DUNELAND SCHOOL CORPORATION

2018 RENOVATIONS AT: BAILLY ELEMENTARY SCHOOL

800 S. 5TH STREET, CHESTERTON, INDIANA 46304
 TRIA PROJECT#: 17-065

PARTIAL FIRST FLOOR PLUMBING
DEMOLITION PLAN

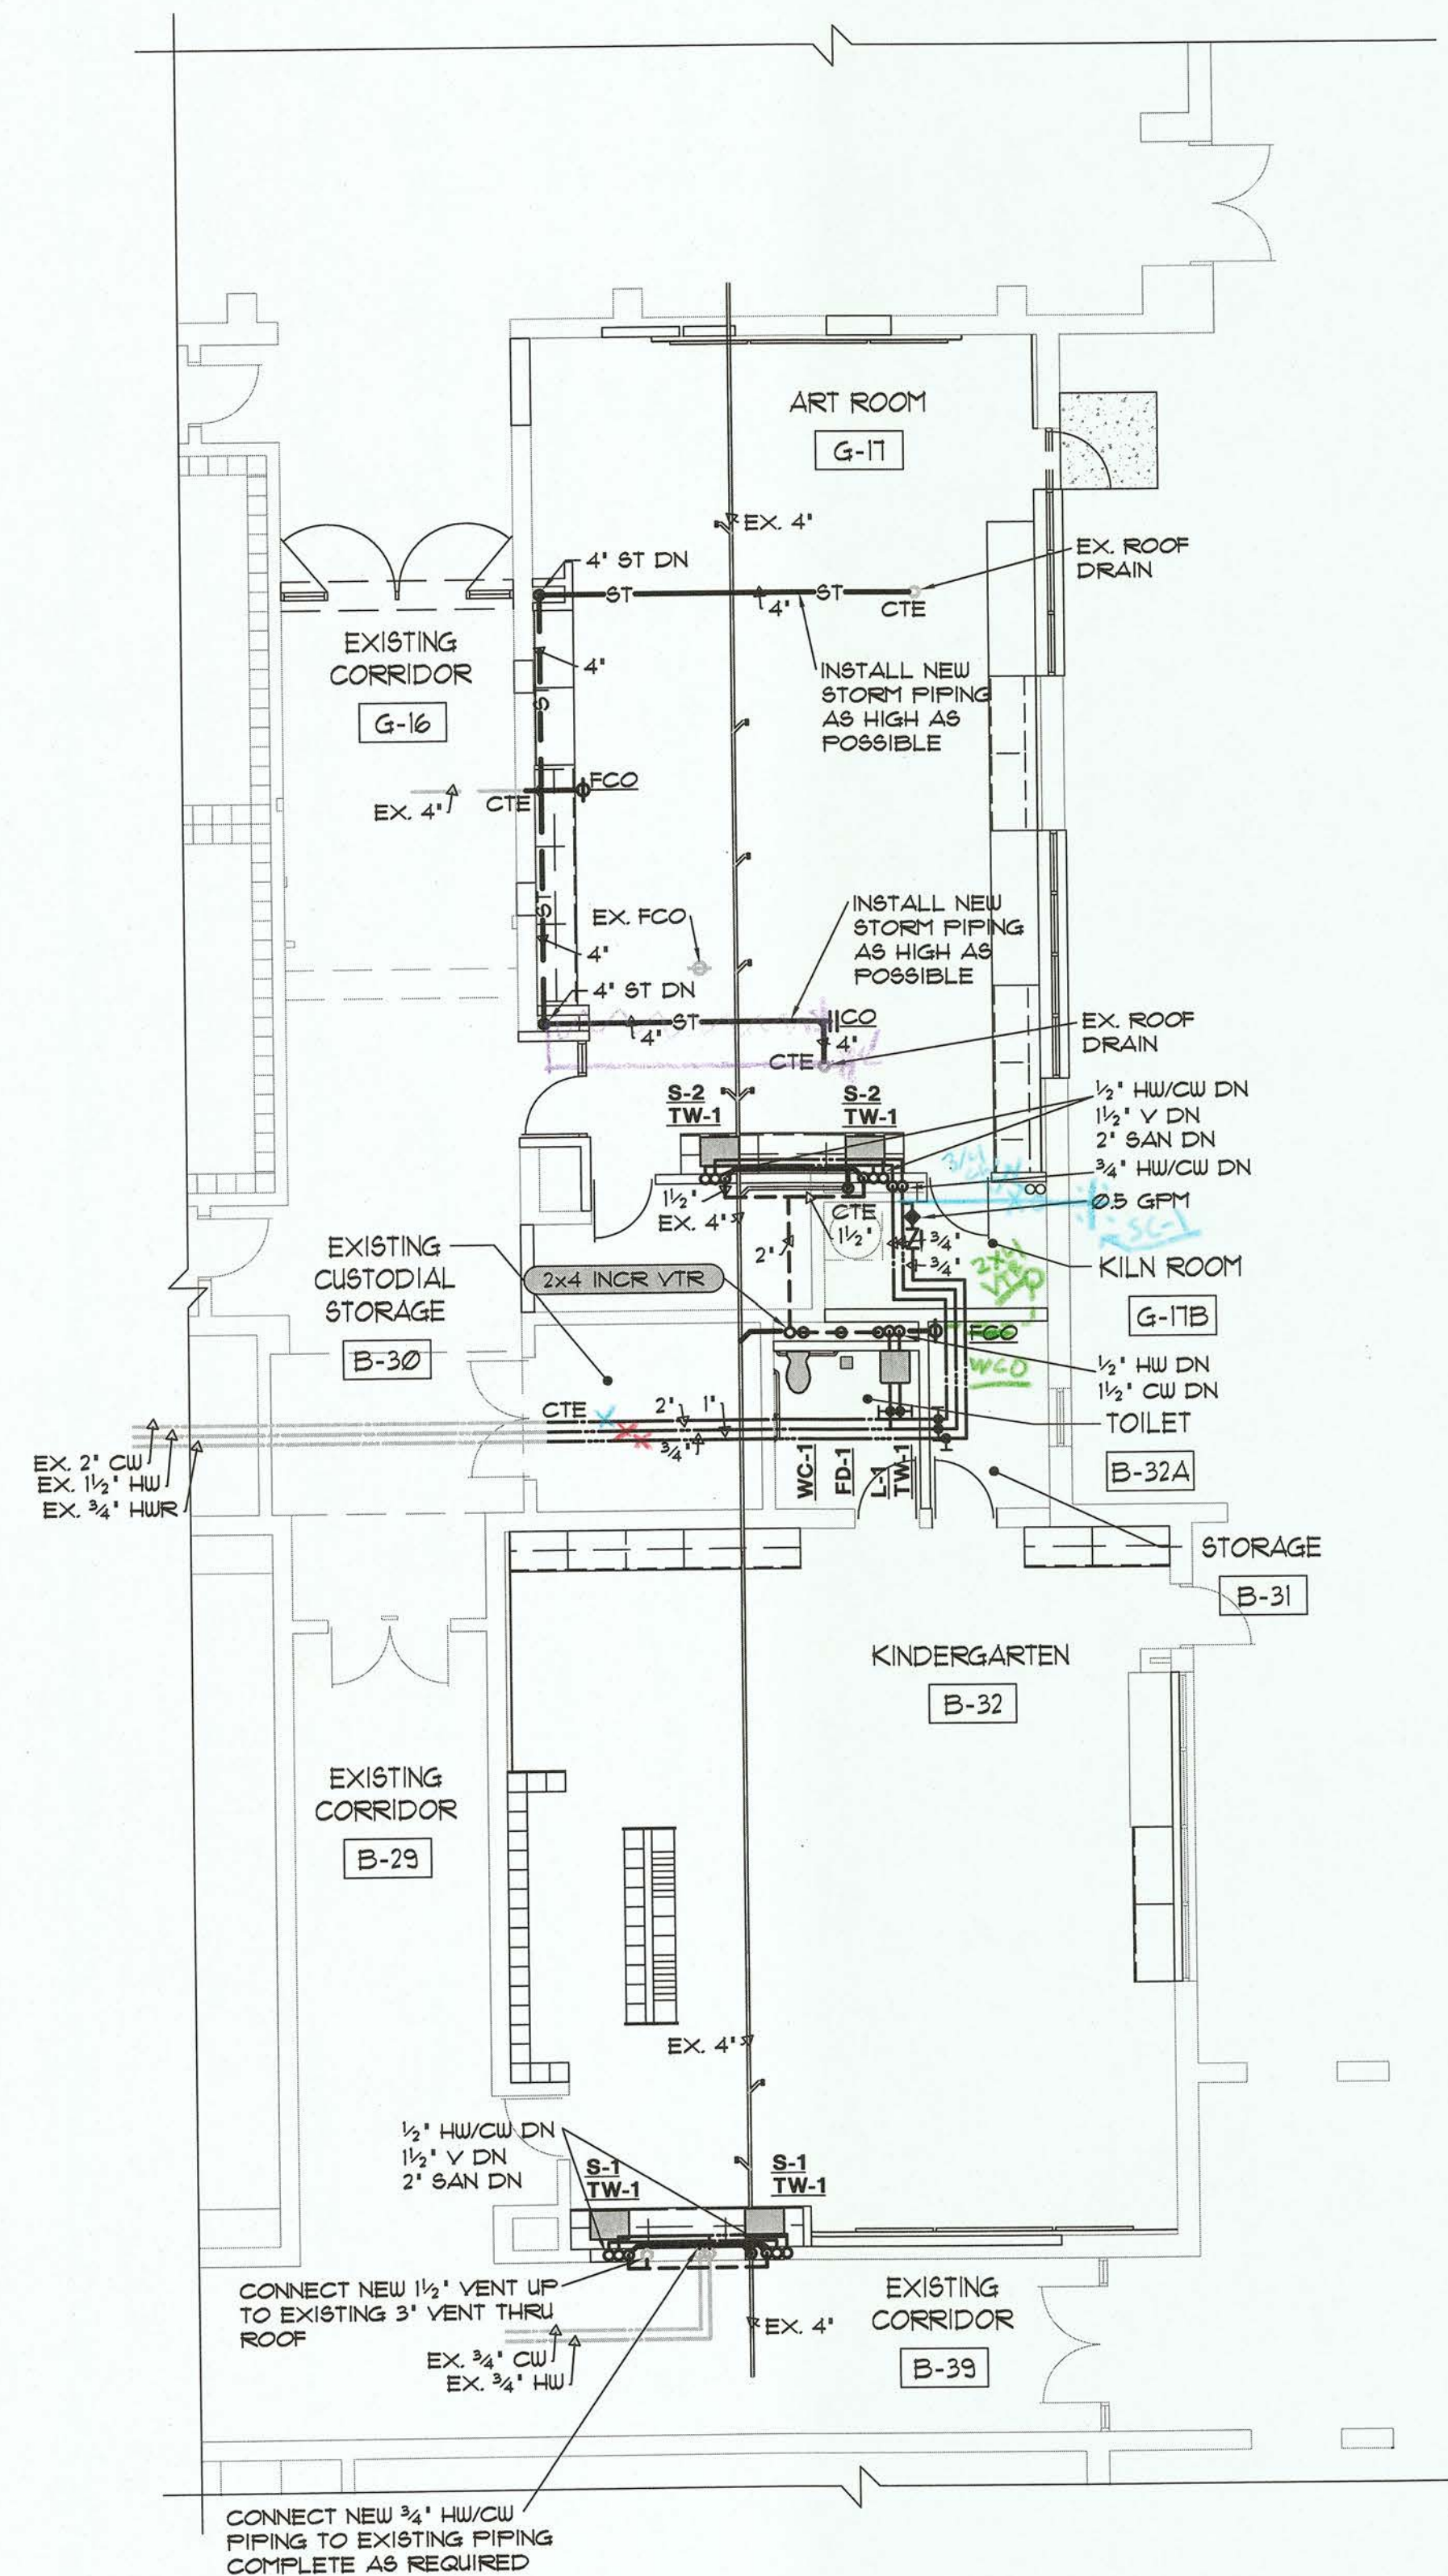
REVISE NOTE 7. DRAWING P.O. 10

"Video tape existing storm piping main to confirm existing branch storm piping connection points, inverts, and conditions of piping as required to complete the work. Provide report indicating connection point locations, inverts, and any deficiencies in the existing storm piping system prior to starting work."

1 PARTIAL FIRST FLOOR ELECTRICAL PLAN
1/8" = 1'-0"

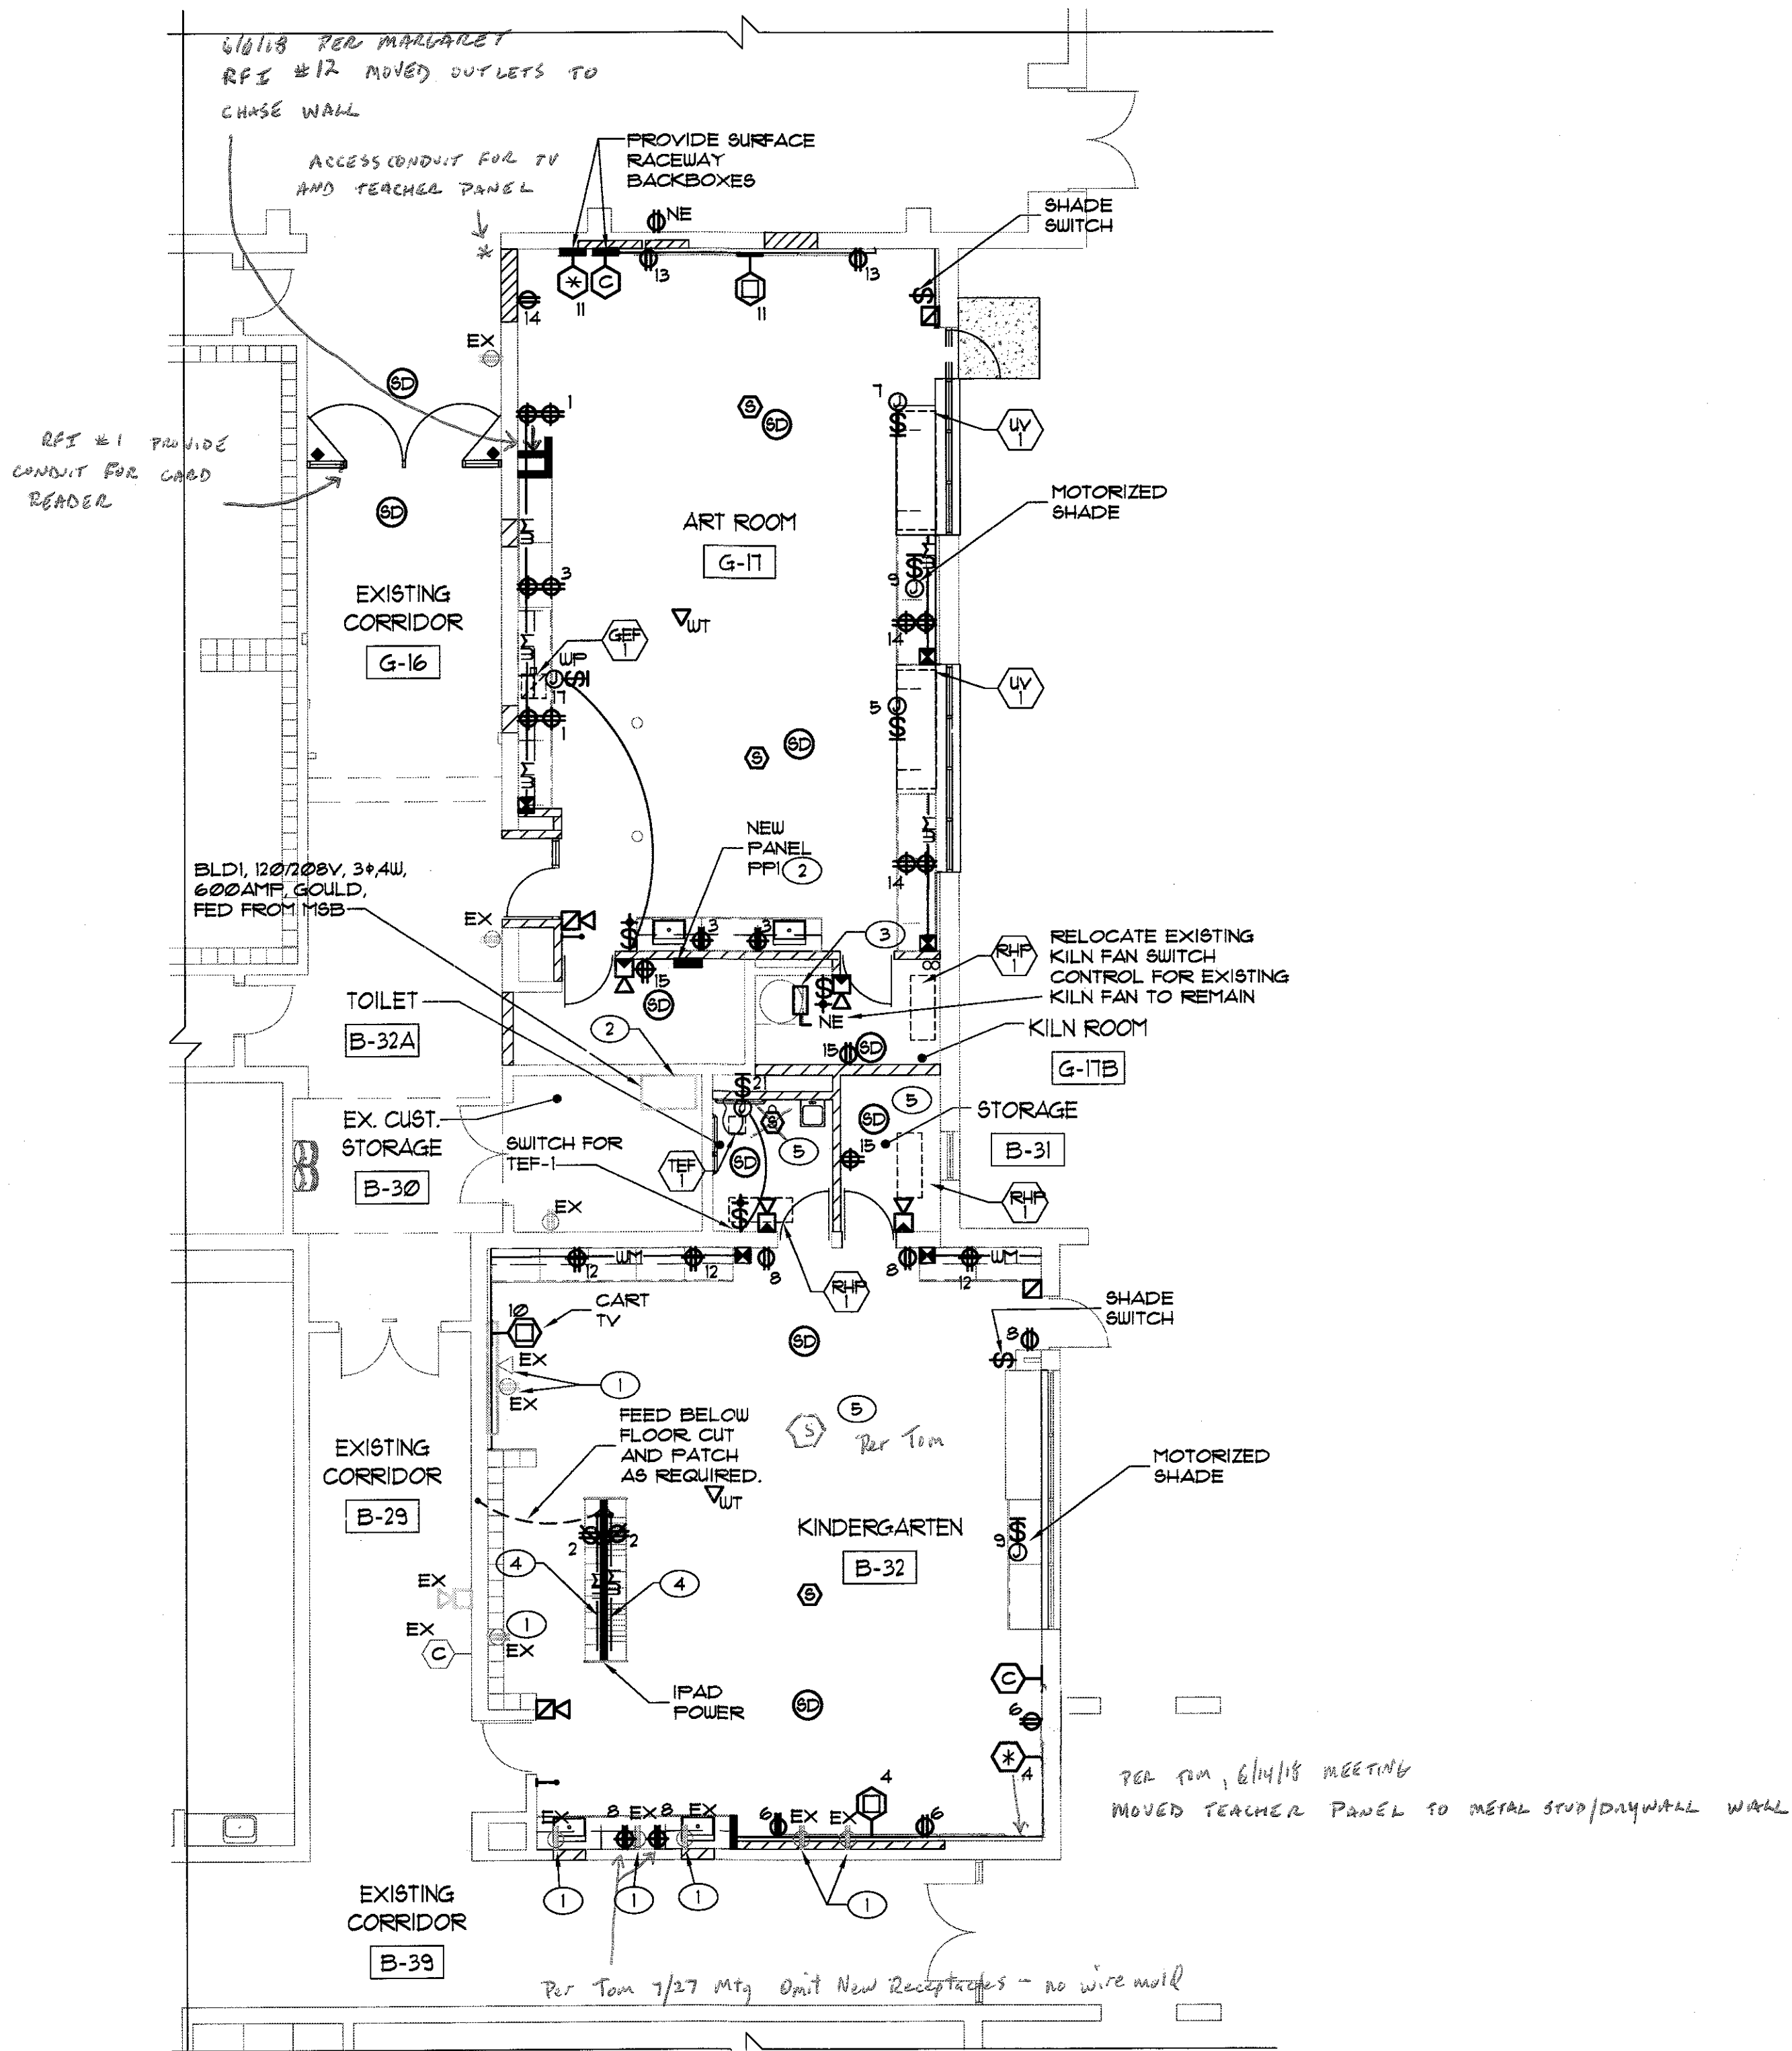
TRANSFERRAL #156 : PER TOM 5/15/18
MOUNT POWER/DATA/FUTURE JUNCTION BOX (BEHIND TV) AT 36" AFF
BOTH ROOMS
